Joseph M. Farley Nuclear Plant – Units 1 and 2 Edwin I. Hatch Nuclear Plant – Units 1 and 2 Vogtle Electric Generating Plant – Units 1 and 2 License Amendment Request to Revise Technical Specifications to Adopt TSTF-545, Revision 3, "TS Inservice Testing Program Removal & Clarify SR Usage Rule Application to Section 5.5 Testing," and to Request an Alternative to the ASME Code

The proposed change revises the Technical Specifications (TS) at FNP, HNP and VEGP to eliminate the "Inservice Testing Program" from the TS 5.5 "Programs and Manuals" section and to add a new defined term, "INSERVICE TESTING PROGRAM," to the TS 1.1 "Definitions" section. This request is consistent with TSTF-545, Revision 3, "TS Inservice Testing Program Removal & Clarify SR Usage Rule Application to Section 5.5 Testing," and is submitted in compliance with the timeframe requirement for continuing to receive enforcement discretion which was established by the February 24, 2012 Enforcement Guidance Memorandum (EGM) 12-001, "Dispositioning Noncompliance with Administrative Controls Technical Specifications Programmatic Requirements that Extend Test Frequencies and Allow Performance of Missed Tests."

Enclosure 2

Main FW Stop Valves and MFRVs and Associated Bypass Valves 3.7.3

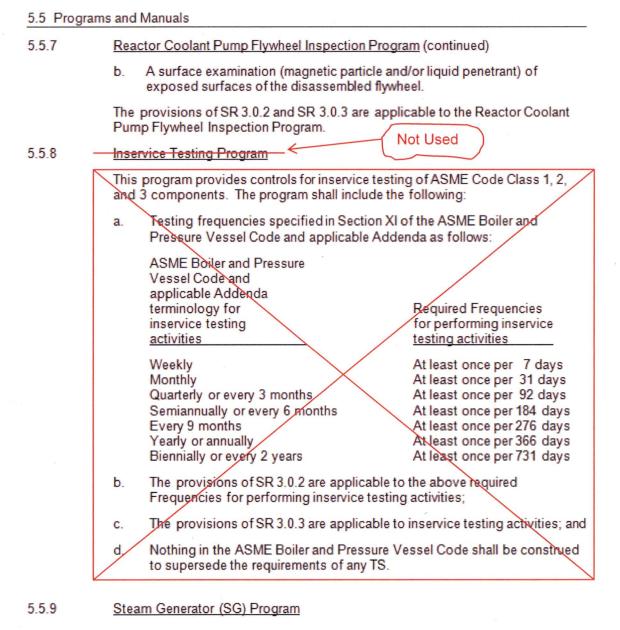
SURVEILLANCE	FREQUENCY
SR 3.7.2.1	Only required to be performed in MODES 1 and 2.	
	Verify closure time of each MSIV is ≤ 7 seconds.	In accordance with th <del>e Inservice Testing Program</del>
	INSERVICE TESTING PROGRAM

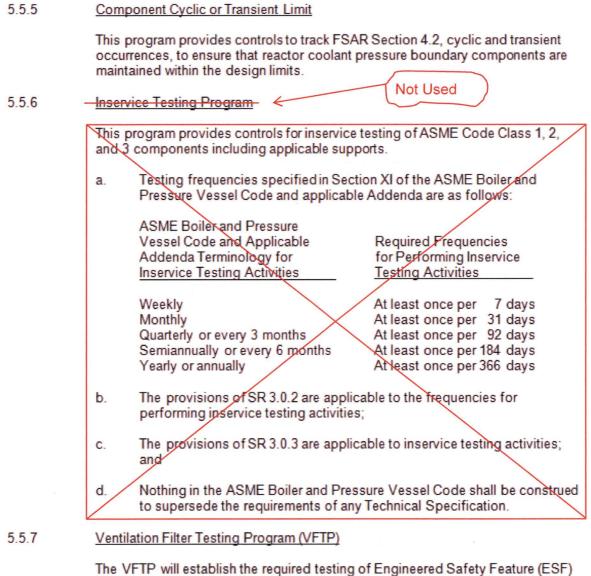
SURVEILLANCE	FREQUENCY
SR 3.6.1.7.1	<ol> <li>Not required to be met for vacuum breakers that are open during Surveillances.</li> <li>Not required to be met for vacuum</li> </ol>	
	breakers open when performing their intended function. 	In accordance with
		the Surveillance Frequency Control Program
SR 3.6.1.7.2	Perform a functional test of each vacuum breaker.	In accordance with the Inservice Testing Program
SR 3.6.1.7.3	Verify the opening setpoint of each vacuum breaker is ≤ 0.5 psid.	In accordance with the Surveillance Frequency Control Program
	INSERVICE TESTING PROGRAM	
HATCH UNIT 1	3.6-18	Amendment No. 266

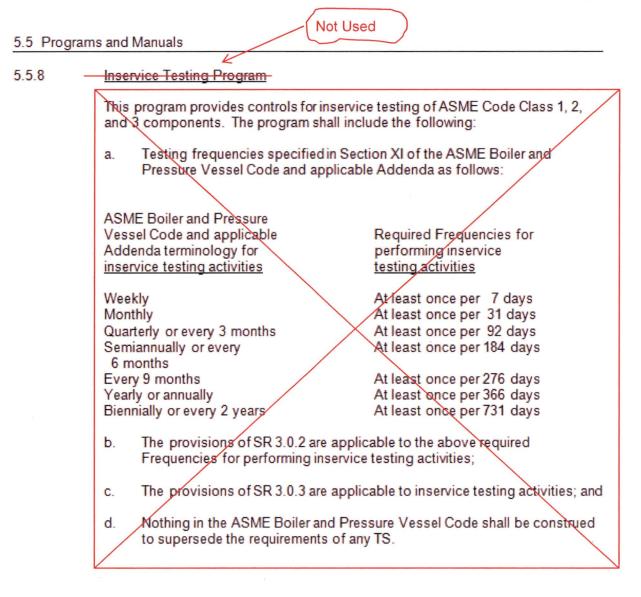
SURVEILLANCE	FREQUENCY
SR 3.7.3.1	Only required to be performed in MODE 1. Verify the closure time of each MFIV, MFRV, and associated bypass valve is ≤5 seconds on an actual or simulated actuation signal.	In accordance with the <del>Inservice Testing Program</del>
	INSERVICE TESTING PROGRA	M
